ADDENDUM NO. 5

Re: Arch Job Number 24001, DCM #2025238, – Plans Dated: 3/31/25

New Lincoln Police Department

ADDENDUM ITEMS:

SHEET
A8.1

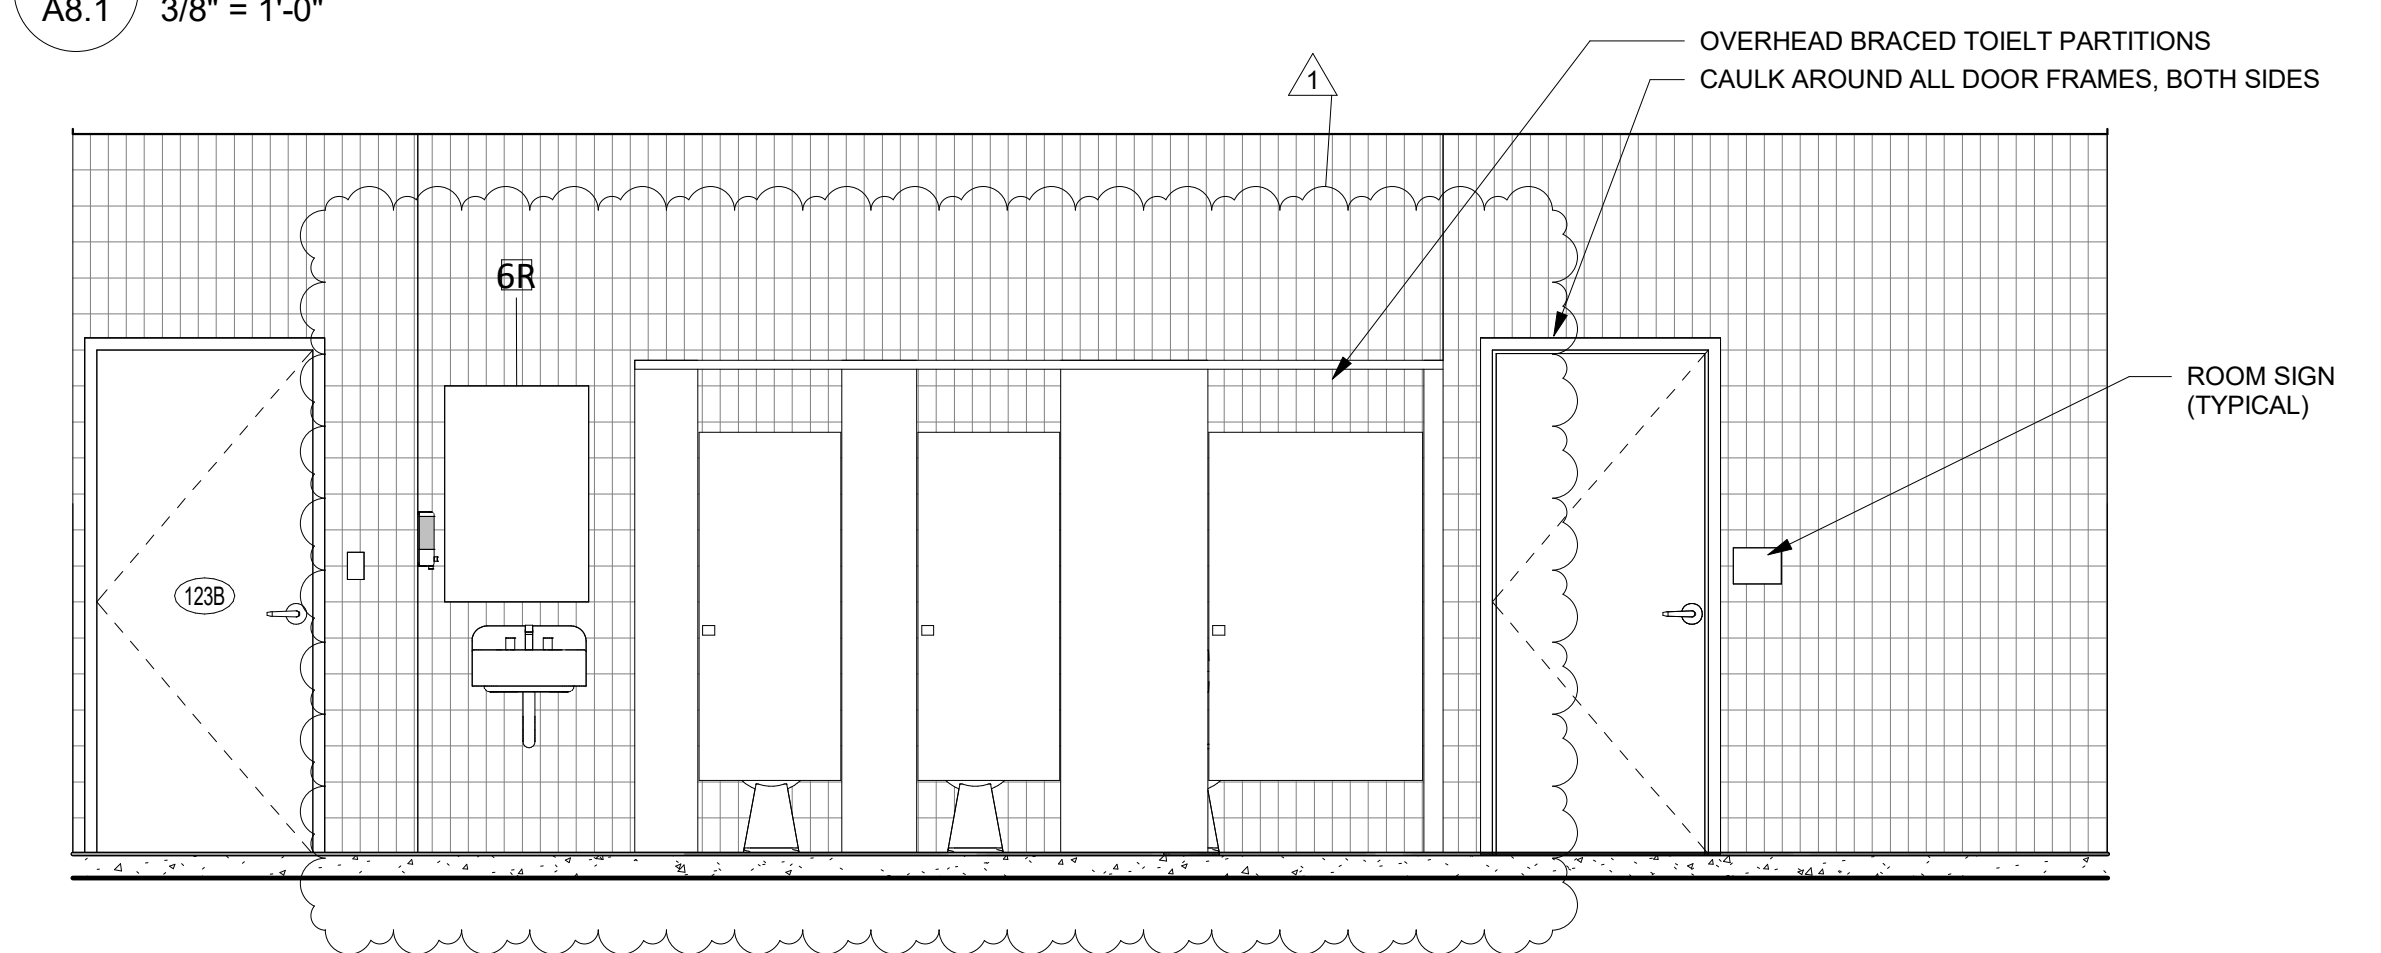
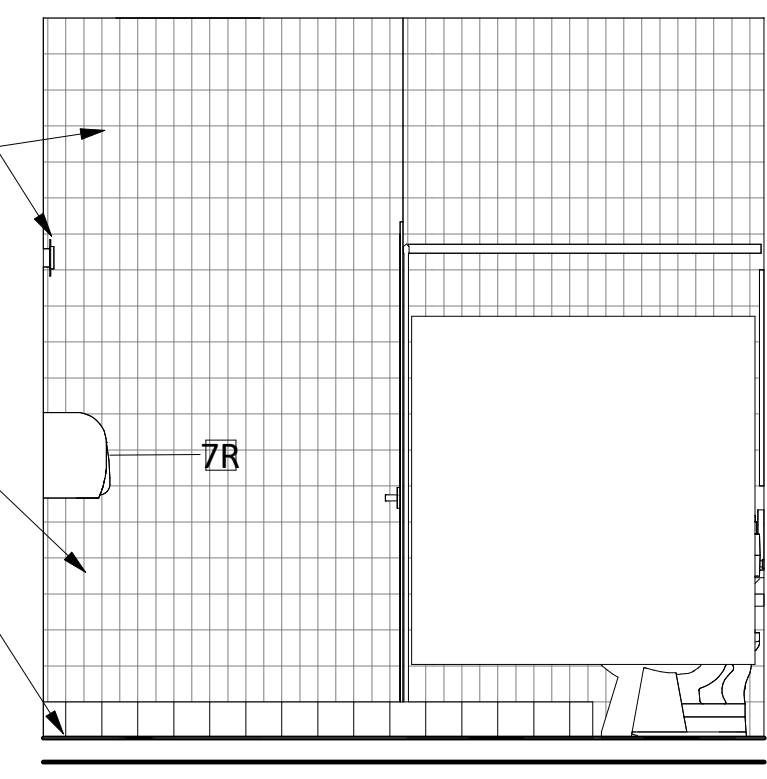
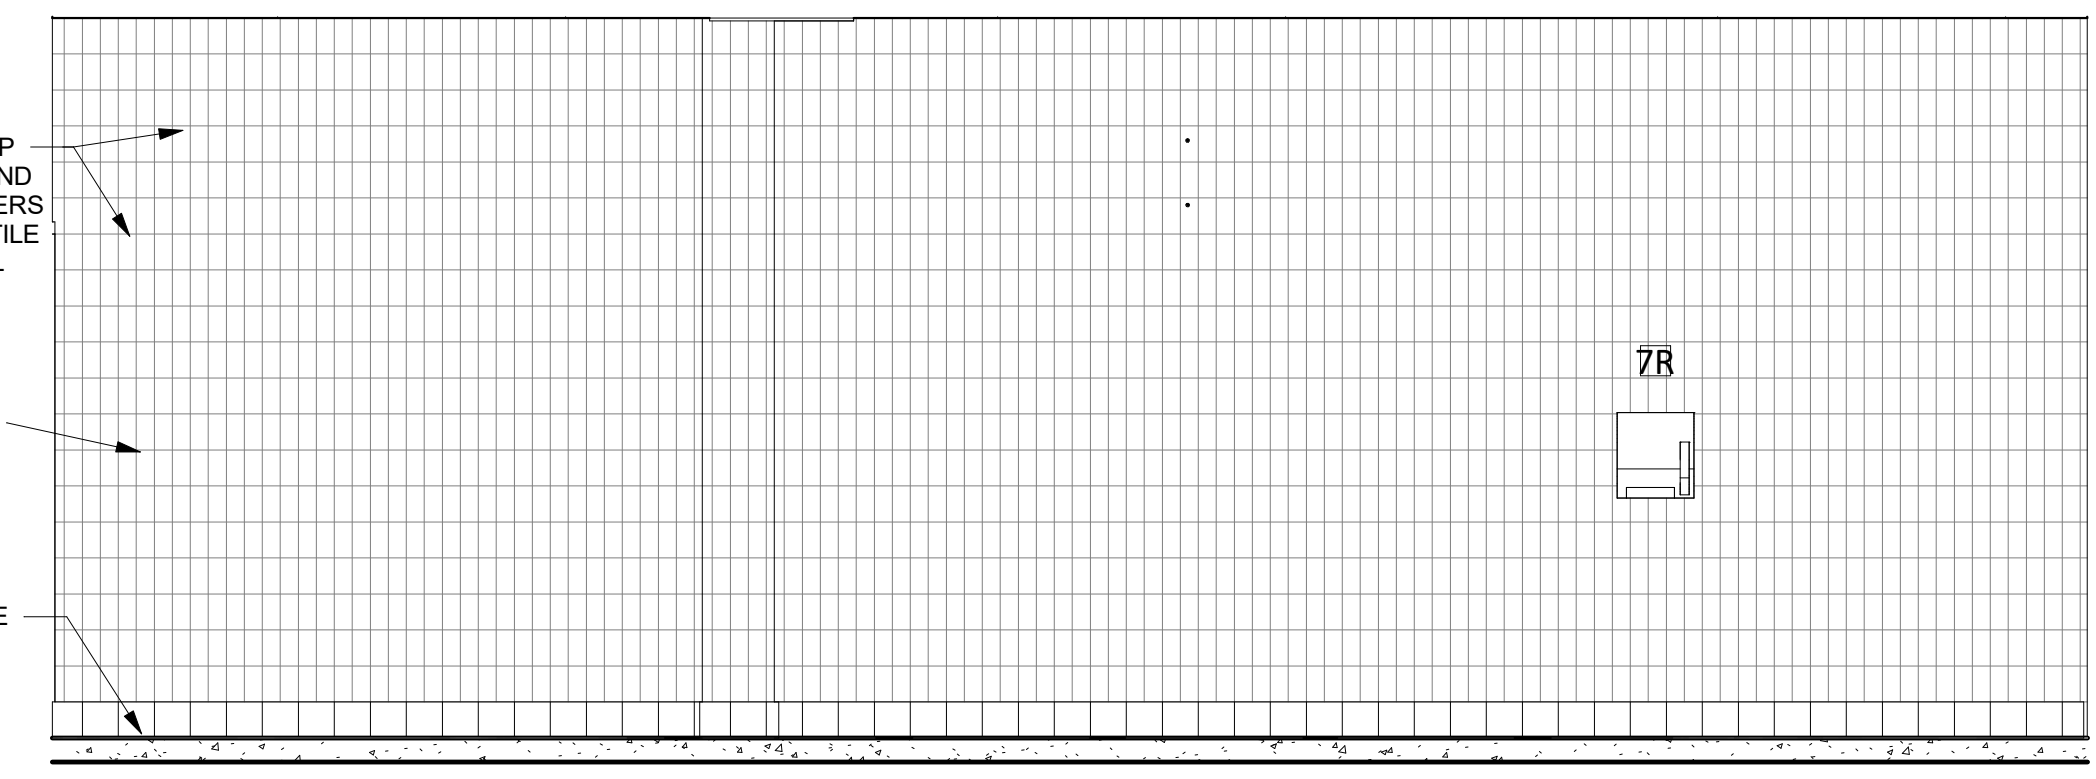
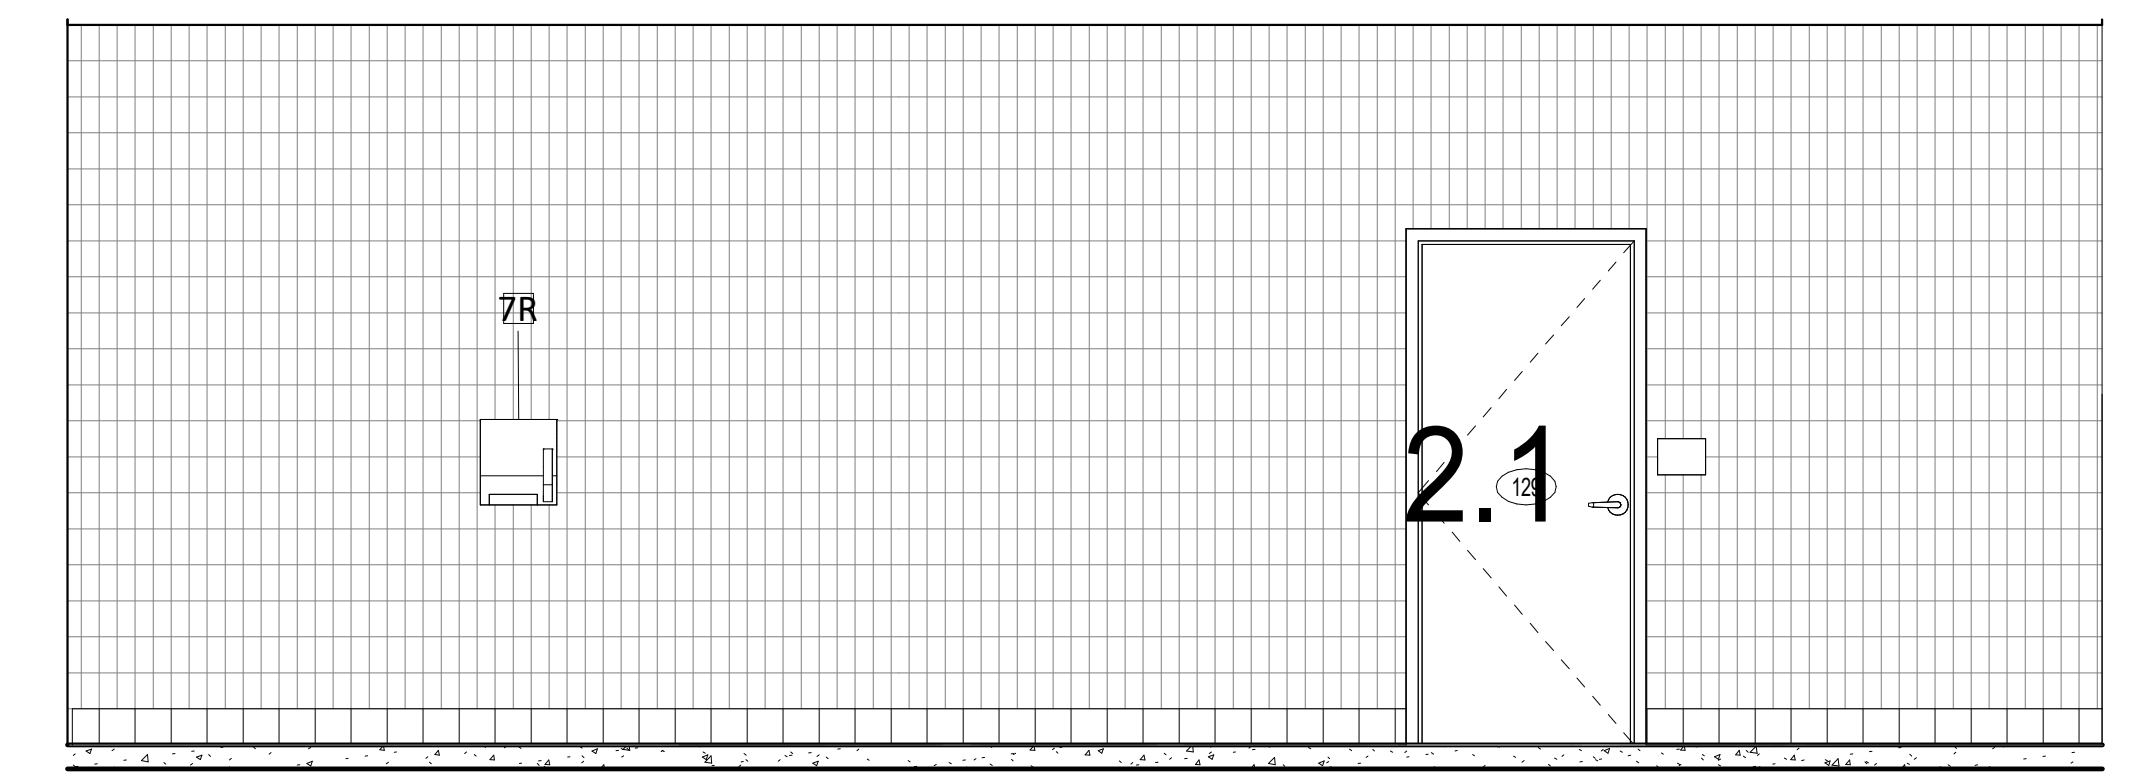
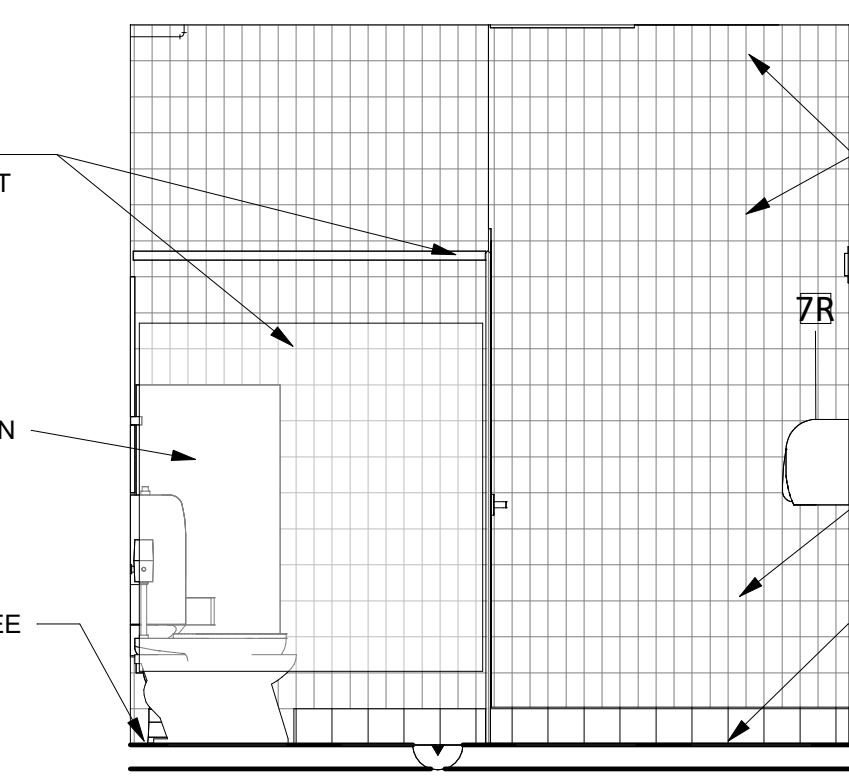
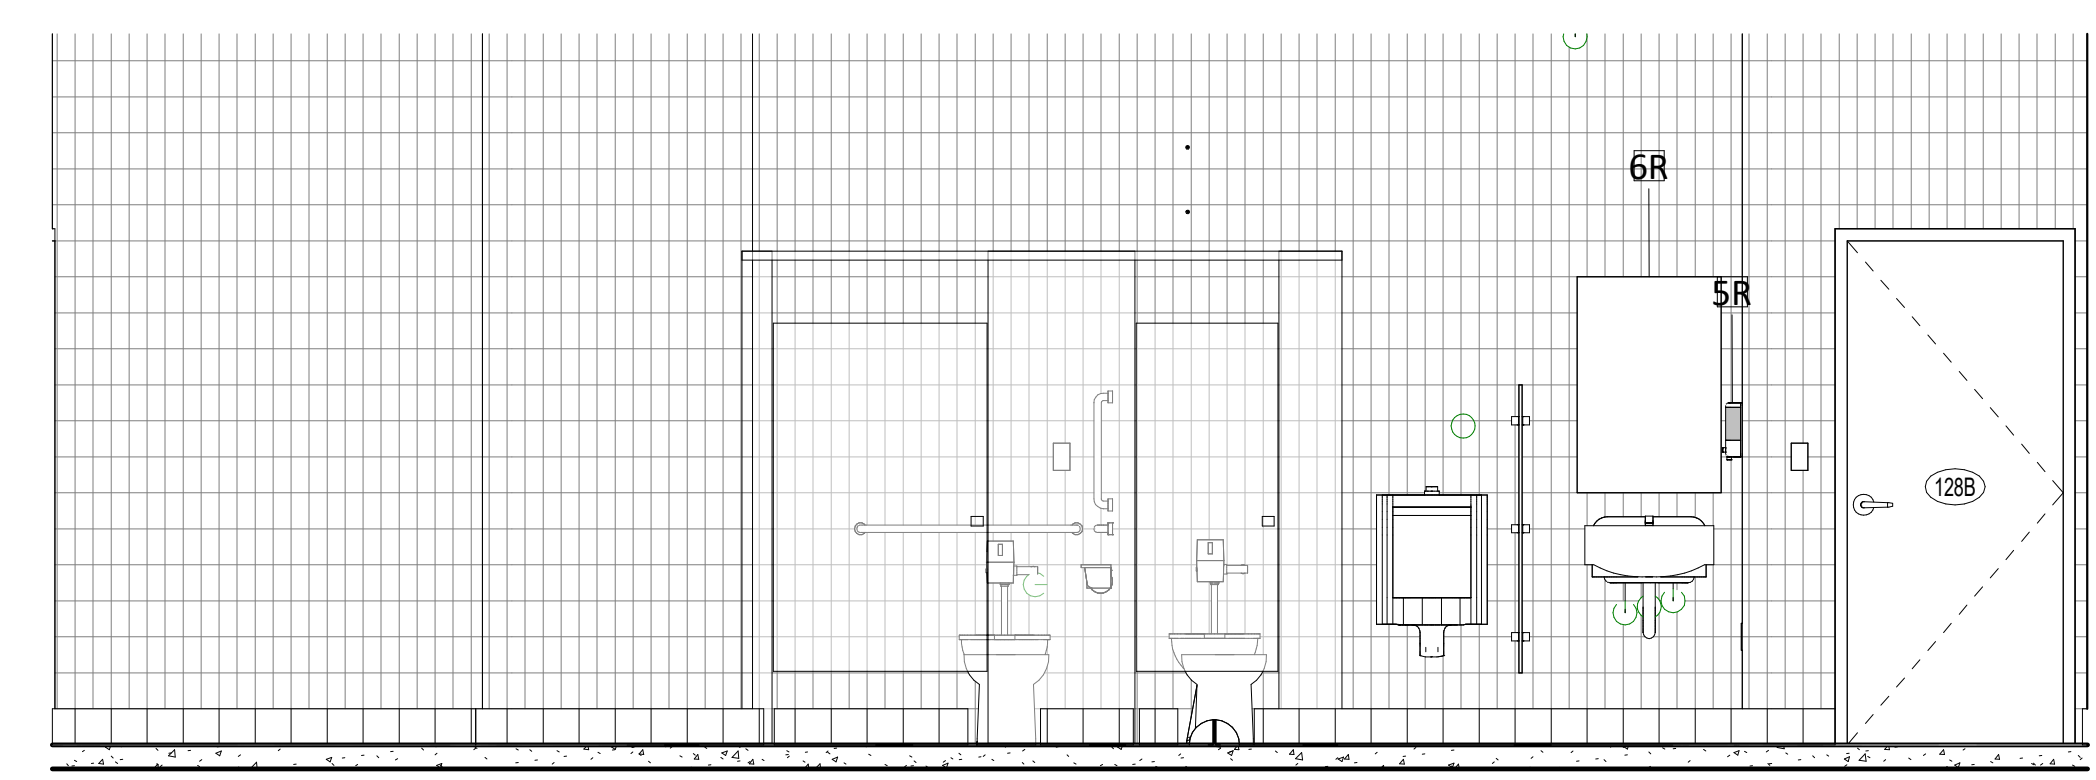
1. **Reference Women 123:** ADA lav clear width shall be 36" clear width in lieu of 30". Shift lavatory to match architectural revised plans.

1. ADA Comply with ADA Standard Figure 305.7.1 Maneuvering Clearance in an Alcove, Forward Approach. See lav in Women 123..
Response: Spacing of toilet compartments and plumbing fixtures has been revised to allow for required clearance at the lavatory. Refer to revised drawings (issued in Addendum)

Revised Sheet A8.1 ENLARGED RESTROOM AND LOCKER ROOM PLANS
